TRANS/WP.29/GRE/2004/10
16 January 2004

PROPOSAL FOR DRAFT AMENDMENTS TO REGULATION No. 70

(Rear marking plates for heavy and long vehicles)

Transmitted by the expert from Japan

Annex 12 - Figure 1

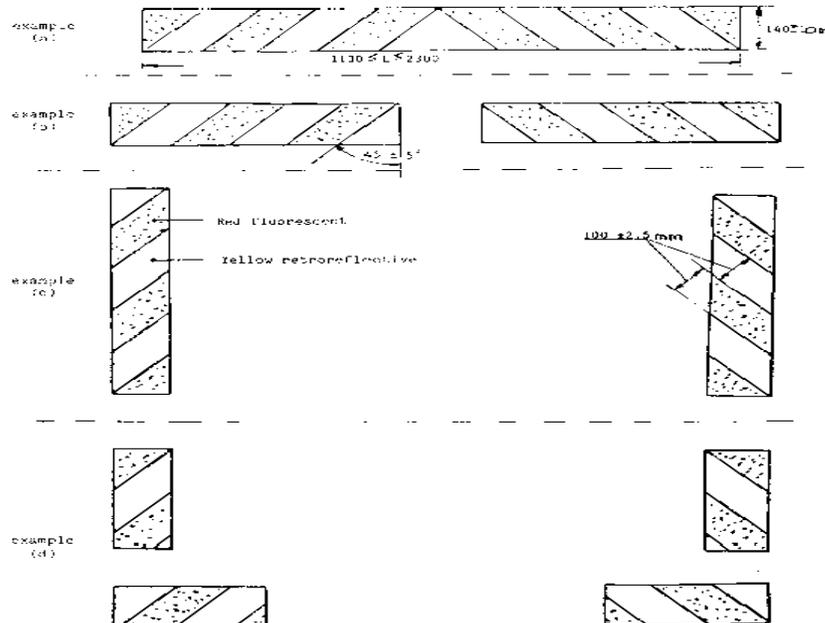
Paragraph 3.2., amend to read:

"... of annex 12, may be reduced, to a minimum of 130 mm, provided that..."

In the above-mentioned paragraph 3.2., the prescribed minimum area (735 cm²) of each marking has been derived from the smallest example (130 x 1130 mm / 2 = 1469 cm² / 2 = 735 cm²) shown in figure 1(a) of annex 12 (see below). Therefore, it is more appropriate to set the minimum length at 130 mm, rather than 140 mm, in harmony with the size of the smallest example. In this case, the length of each rear marking plates may be reduced to 130 mm.
